## **Report to Planning and Environment Committee**

**Subject:** Four Fourteen Inc.

414-418 Old Wonderland Road

# Re: Site Plan Control Approval for, 414-418 Old Wonderland Road. London ON – File Number SPA20-103

Image 1: Landscape Plan identifying proposed fencing type around the site. Red indicates the 2.1 metre board-on-board fence. Blue indicates the 1.2 metre chain link fence.

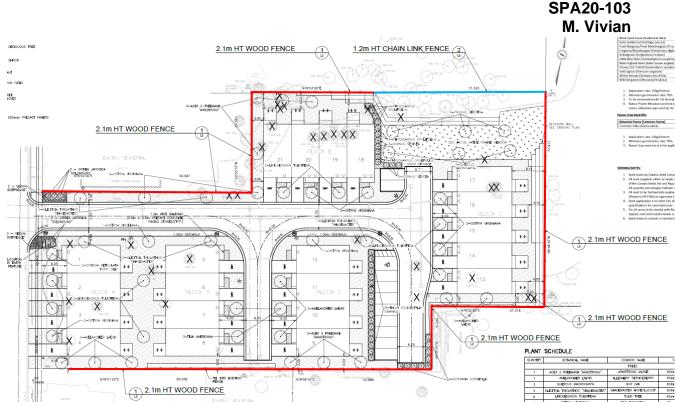
The Site Plan Control By-law contemplates board on board privacy fencing to a maximum height of 1.8 metres (6 feet). In order to address the resolution of Council, the applicant is proposing a board-on-board fence with a height of 2.1 along the perimeter of most of the site. Staff are in concurrence with the height in order to address the request of Council. Along the north property boundary, staff have worked with the applicant to provide a fencing strategy to mitigate any impacts on the Natural Heritage Feature. Board-on-Board fencing is proposed along the northerly lot lie to the end of Unit 18. East of unit 18, and within the OS5 (19) zone the applicant is proposing chain link fencing at 1.2 metres in height (identified in blue in Image 1 below). The chain link fencing within this area is proposed to not restrict amphibianand other animal movements to the feature and to reduce the impact on the natural area. Given that this area to be fenced with chain link is within densely treed area, staff have no concerns from a privacy aspect and are of the opinion that the intent of the Council Resolution is maintained.

While a 2.1 metre board-on-board fence is proposed along the east property boundary, as requested by Council, it is noted that the lands to the east are currently undeveloped and therefore, there are no existing privacy issues for this section of land. The lands slope dramatically to the east, and retaining walls are proposed along the eastern property boundary. Despite this, and in accordance with Council direction, staff are requiring a 2.1 metre board-on-board fence along this lot line. The Site Plan Control Bylaw provides rationale for requesting board-on-board fencing for developments of this nature. An increase in height to 2.1m for fencing along this property line is reasonable. The fencing provides screening qualities for the undeveloped easterly lands at such a time when they are developed, despite the site being significantly lower than the subject lands.

A 2.1 metre board-on-board fence is proposed along the entire southern property boundary, consistent with Council's Resolution. While there is an existing hedge within the south-east corner, the proposed fence should have no impact on the health of the hedge and staff have provided comments to consider moving the fencing to be located solely within the subject lands to avoid any potential impacts.

Staff are satisfied that the proposed fencing meets the intent of Council's Resolution.

### Photometric Plan

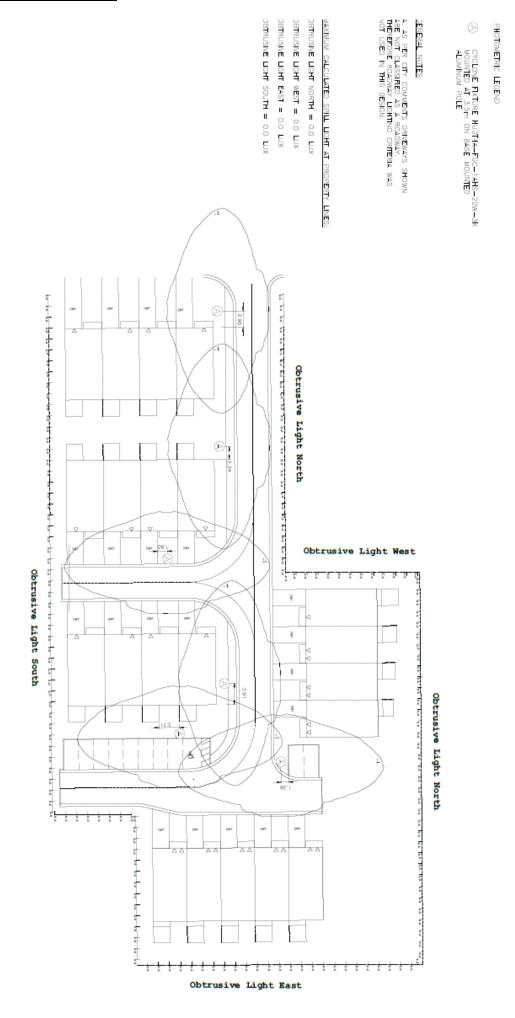
- 5. Revise the photometric plan to provide a light cast of 0.0 to 0.1 along the property boundaries. The current proposal indicates light casts of up to 0.9 abutting property boundaries which exceeds the minimum staff would support. Refer to Section 8.2 of the Site Plan Control By-law to ensure the proposed light standards meet the criteria for bird friendly design.
- To enhance privacy around the site, provide for additional landscaping to fill in gaps between the proposed trees.

standards within the development. The photometric plans are evaluated based on the intensity of light and the impact on surrounding properties. Currently, the light cast on the abutting lands is shown at 0.0 foot-candles along all property boundaries. Staff are satisfied that light cast will not trespass beyond the property lines, in accordance with the Site Plan Control By-law. This is further enhanced by the proposed 2.1m board-on-board fencing.

### Elevations - Townhouses

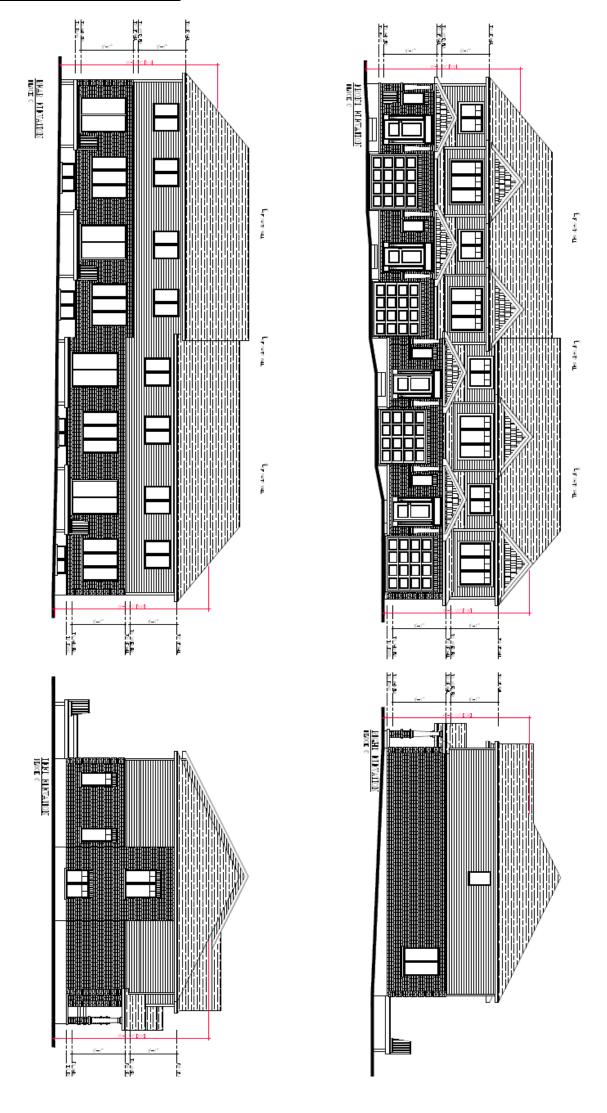
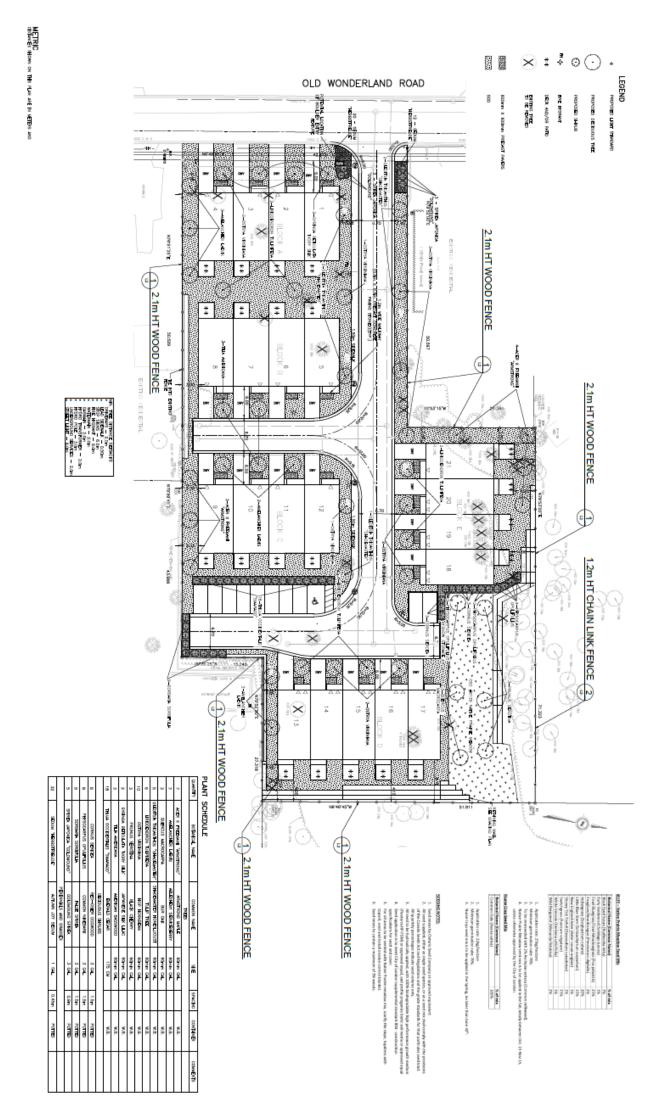
- We acknowledge the enhanced architectural treatment proposed on North Elevations for Blocks 'A, B, C and D' and East Elevation for Block 'E' and is acceptable.
- 6. Label the materials and colour on all the elevations provided.
